CABINET MEMBER FOR HIGHWAY MANAGEMENT – 16 NOVEMBER 2023

LYNEHAM: PROPOSED 20MPH SPEED LIMITS

Report by Corporate Director, Environment and Place

ANNEX 1

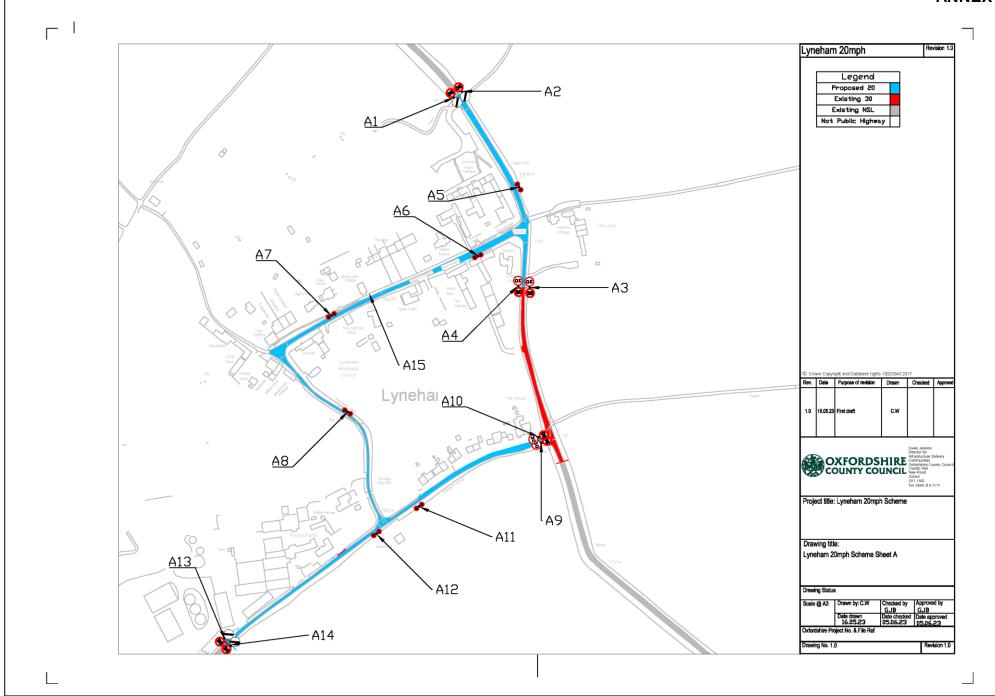
(2) Lyneham Parish Council	Support (with Concerns) – see Annex 4 for original response. 01/11/2023 update: we would like the existing 30 through road to remain as such and the 20's implemented on the residential road/lane/street.

ANNEX 2

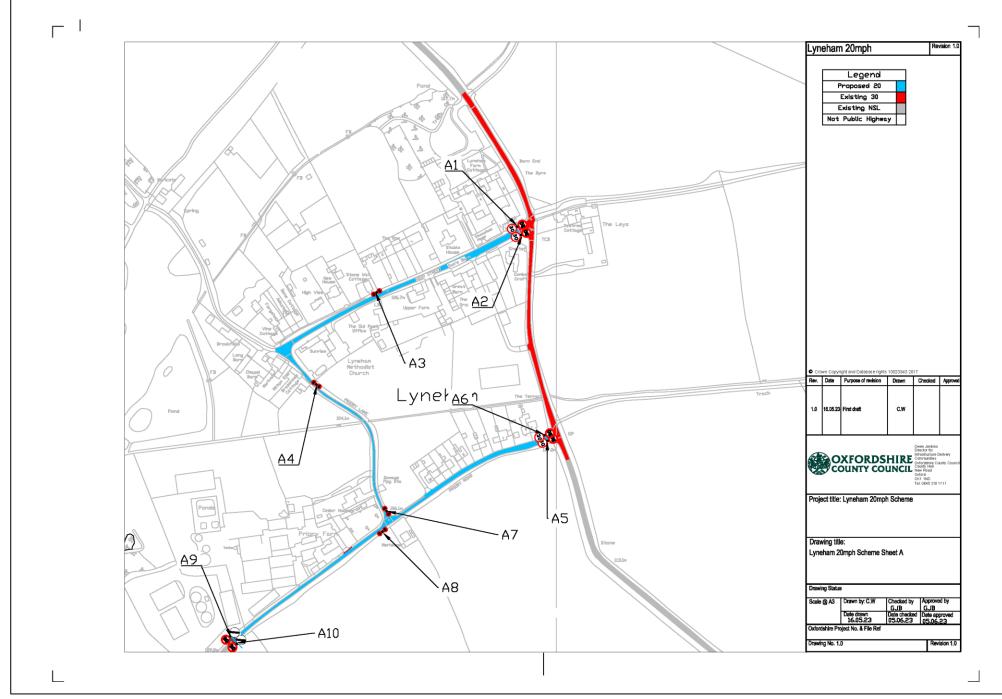
The Cabinet Member for Highway Management is RECOMMENDED to approve the introduction of 20mph speed limits in Lyneham as amended from the advertised proposals to now exclude the through road in accordance with community wishes.
